City of Surrey
PLANNING & DEVELOPMENT REPORT

File: 7915-0069-00

Planning Report Date: February 1, 2016

RE: **Engineering Requirements
Location: 18319 20 Ave**

SCS Consulting
Residential Development Plan
18319 - 20th Avenue, Surrey

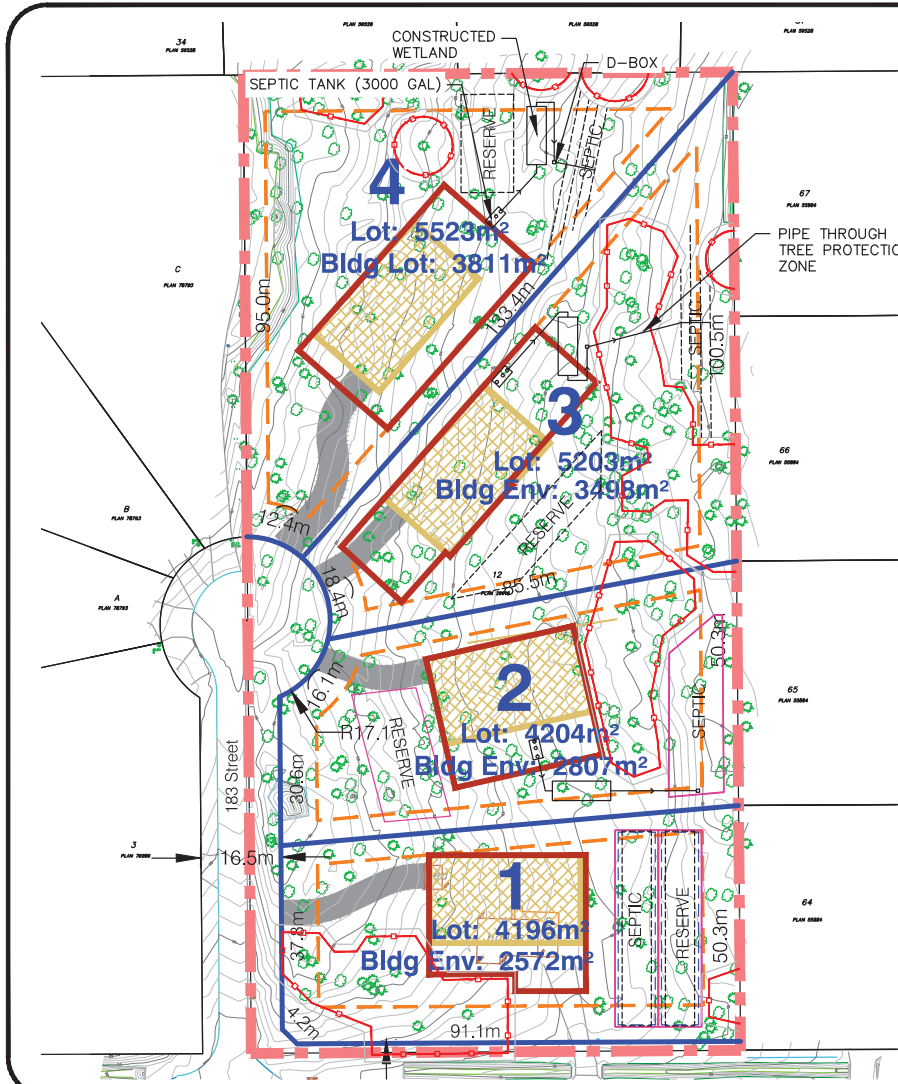
- The Engineering Department, Sanitary Section, does not support the servicing of the proposed lots via onsite septic systems as they do not meet the minimum parcel size for septic systems. The Engineering Department is prepared to consider a variance to allow a 3 -lot subdivision rather than a 4 -lot subdivision proposed by the applicant.

The Engineering Department does not support the varying of the Subdivision and Development Bylaw's on-site sewage disposal requirement in order to permit a 4 lot subdivision. Compliance with the Bylaw would permit a 2 lot subdivision. The Engineering Department is prepared, subject to detailed design that minimizes the impacts of on-site sewage disposal, to support a variance to permit a 3 lot subdivision.

Appendix 1 - Proposed Development 12-0164 in relation with the downstream farmhouses on well water

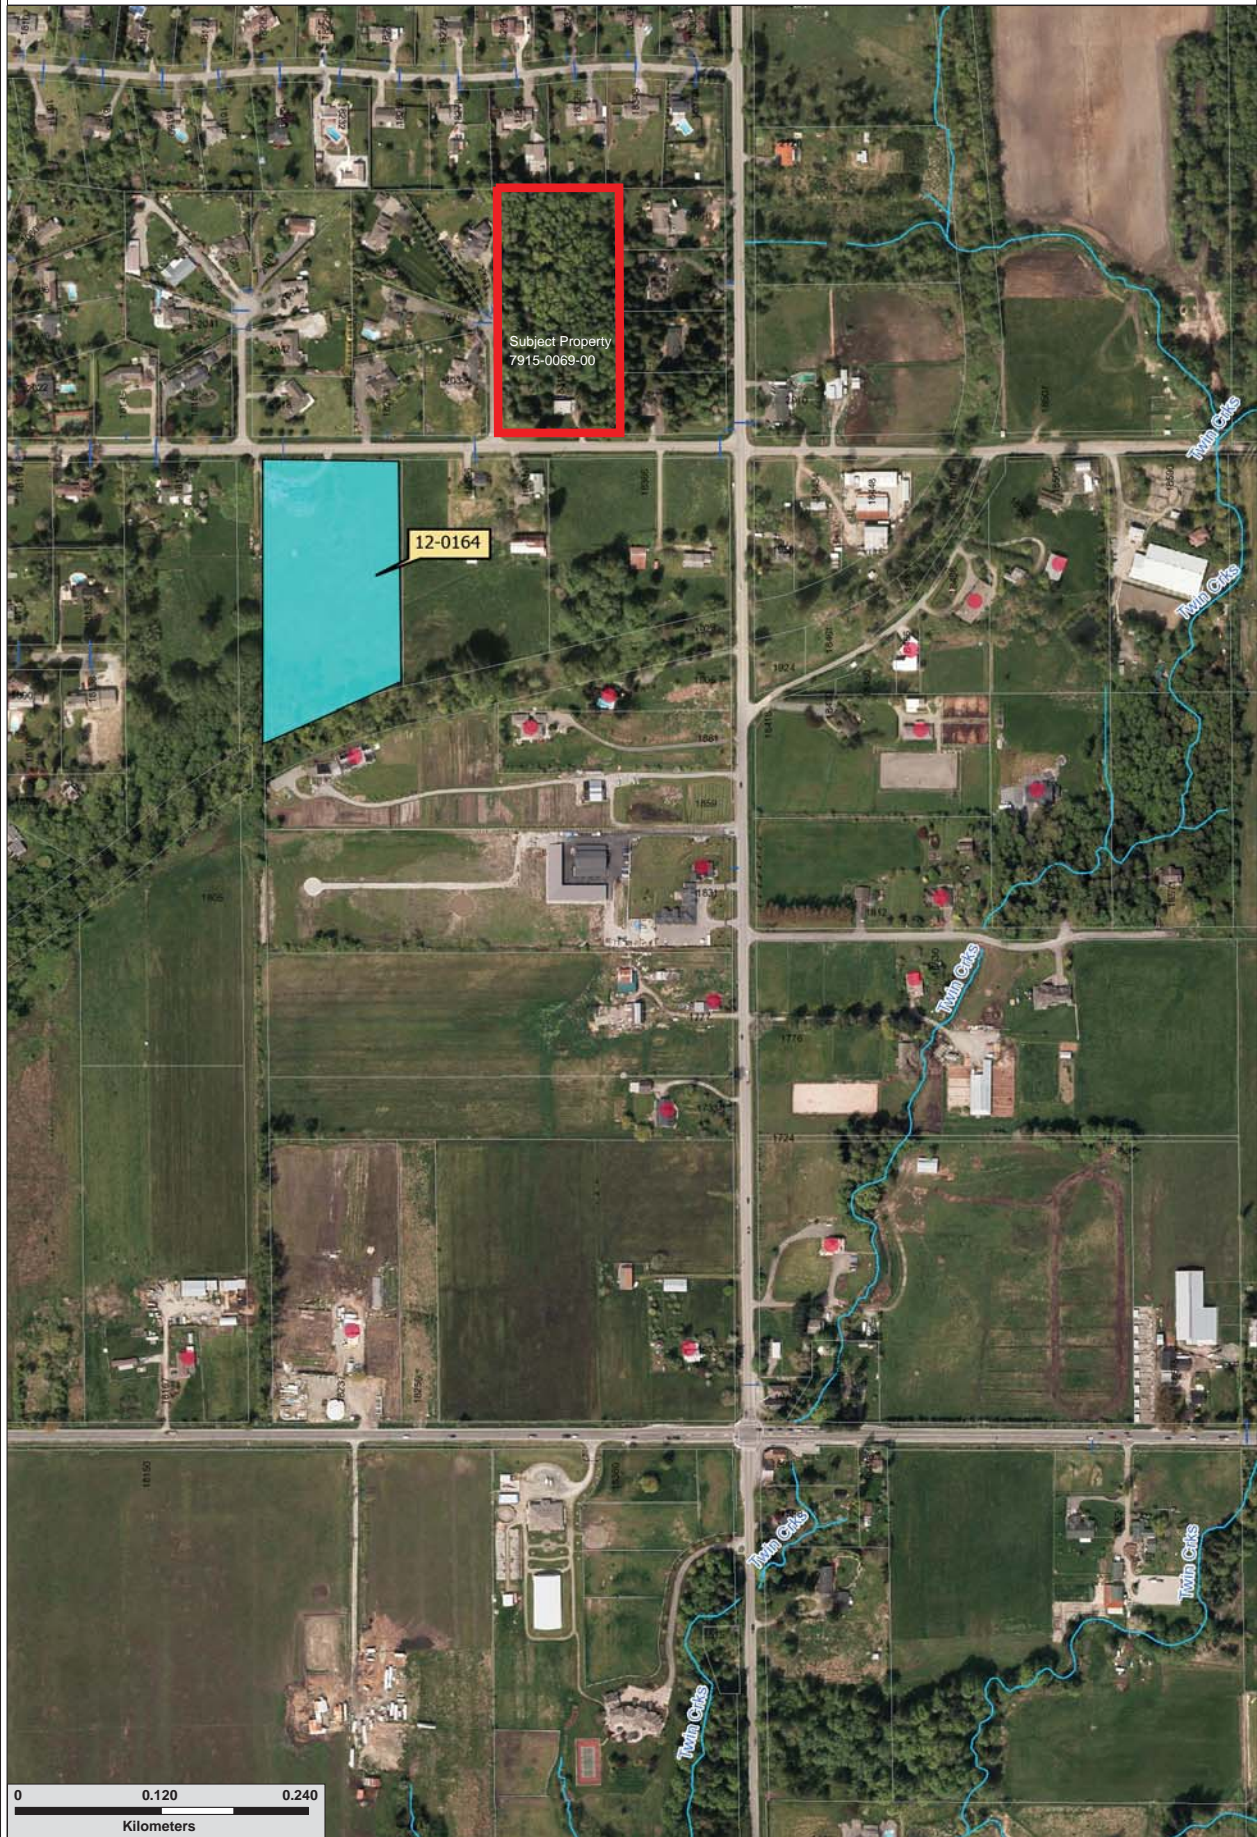
- Finally, there are downstream dwellings that are on well water supply. Appendix IV is a map showing the downstream dwellings that are on well water supply, which would be impacted should upstream septic fields begin to fail.
